## NuLu Review Overlay District

### Report to the Committee

**Case No:** 23-OVERLAY-0012  
**Classification:** Non-Expedited  
**Meeting Date:** September 20, 2023

**Property Address:** 615 & 625 E. Market Street

Site Plan

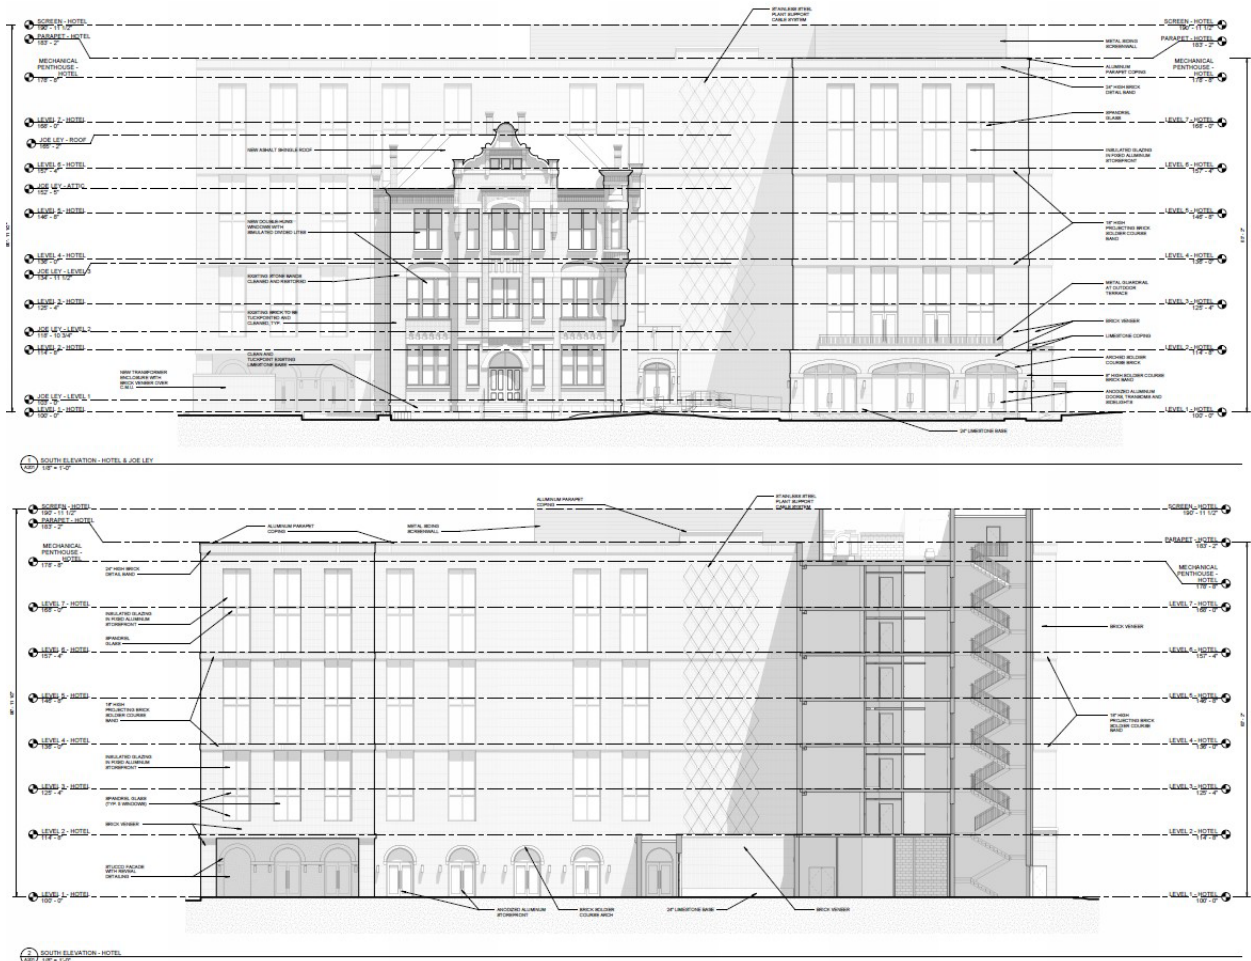
A valet/temporary parking lot is proposed to the west of the Joe Ley building, adjacent to the street, which will require a new curb cut accessed from E. Market Street. While the guidelines encourage parking areas be located to and accessed through the rear of the property when an alley is present, Billy Goat Strut alley is narrow and unimproved, which would present difficulty for adequate traffic movement. Details have not been provided for how the parking lot will be buffered. Staff recommends a minimum 4' wide landscape buffer between the sidewalk and the parking surface that includes a wall or fence a minimum of 36" high that adequately screens parked vehicles from the street.

A ground level pool with two accessory outbuildings is proposed in front of the east wing addition and the street. While an outdoor pool use is common in conjunction with a hotel, the proposed location in the front yard along a main commercial corridor is not common and there are no other such pools in the district. As the pool is a private and seasonal use that is limited to guests, ideally it would be located to the interior or rear of the site, or on

Staff does not feel enough information has been provided for the open areas around the buildings, particularly regarding the street wall, pool area landscaping, and two pool structures, to adequately assess that portion of the proposal for compliance with the guidelines. Based on the guidelines, staff strongly recommends that the pool be located elsewhere on the property, or a proper building be sited between the pool and the sidewalk. At a minimum, in order to better comply with the guidelines,

1. The pool area should be redesigned to either extend the building façade closer to the street for a consistent setback and street wall with the other historic structure on this block with outdoor seating between the new setback and the sidewalk, or;
2. Incorporate public space like a plaza and outdoor seating where the pool is currently located to allow increased activity and use along the street and interaction with the pedestrian.

- 1. This approval does not include the front pool, its accessory buildings, and its surrounding area. The applicant shall provide additional details regarding all design elements related to this improvement and it shall be reviewed and acted on subsequently.**

**E. Market (South) Façade with and without the Joe Ley building**

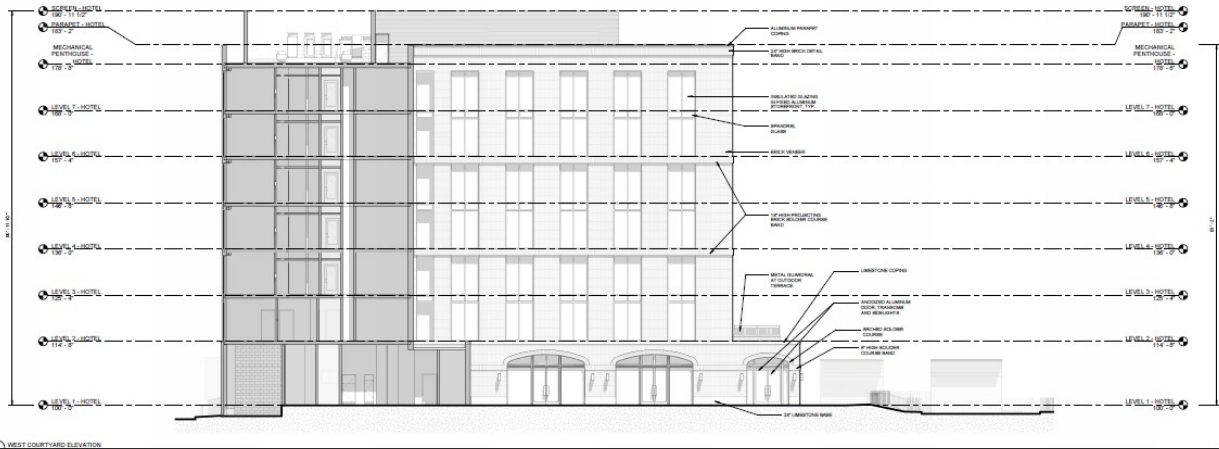
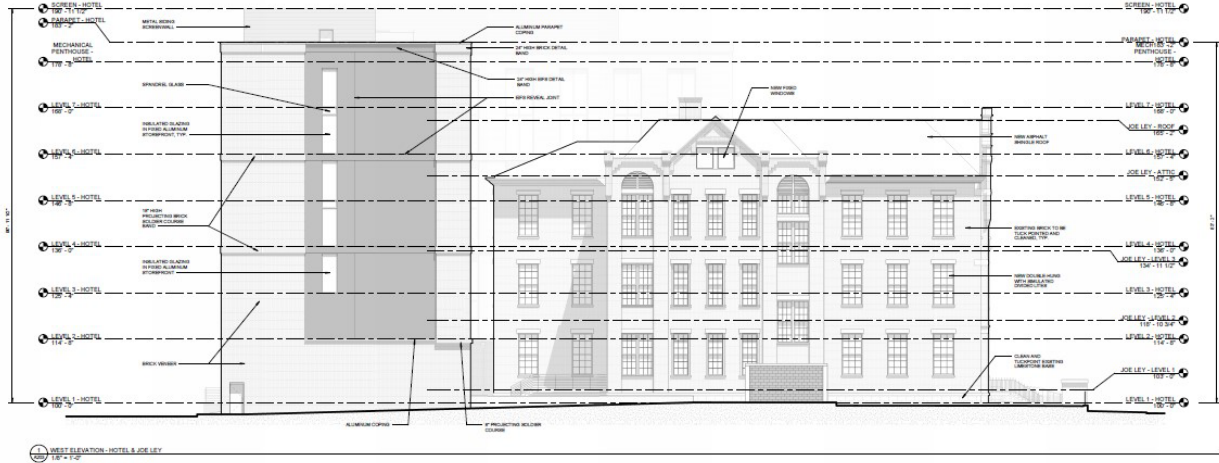
Based on the renderings and elevations provided as of the drafting of this report, staff prefers the mostly glass hyphen structure between the existing Joe Ley building and the new addition as shown in previously submitted renderings. The use of glass is less visually intrusive to the historic Joe Ley building and provides a more seamless connection between the historic and new portions of the site. Staff recommends this hyphen retain the glass design as previously proposed.

- 2. All glass on the ground level of E. Market Street facing facades shall be clear. Front glass shall not be tinted, smoked, or have added reflection or mirroring. If the glass is low-E, it shall be clear.**

- 3. The previously proposed, mostly glass hyphen between the existing Joe Ley building and the new addition will be reincorporated into the final design.**
